Defrost Control Board with Plastic stand-offs. Installed on all JAZ heat pump models with date codes of M1707 or later.

Defrost Control Board with Metal stand-offs. Installed on all JAZ heat pump models with date codes prior to M1707.

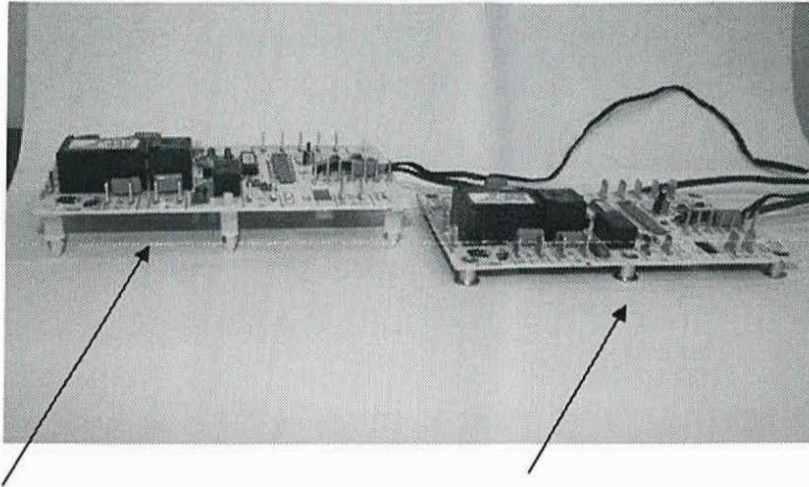
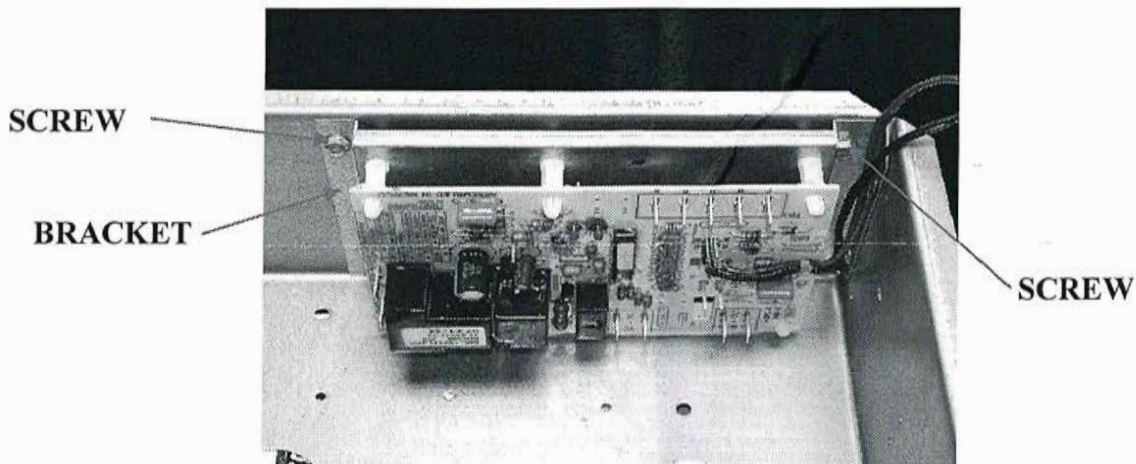
Note: The defrost sensor provided with this kit may be longer than the one provided with the original defrost control board. Neatly gather and secure all excess wiring, keeping it away from hot refrigeration components, moving parts, or sharp edges.

1. If the heat pump is manufactured prior to date code M1707, remove the old control board and install the bracket to the inside of the control box using the 2 sheet metal screws included in the kit.
2. Align plastic stand offs with the holes located in the bracket and snap the control board into place.
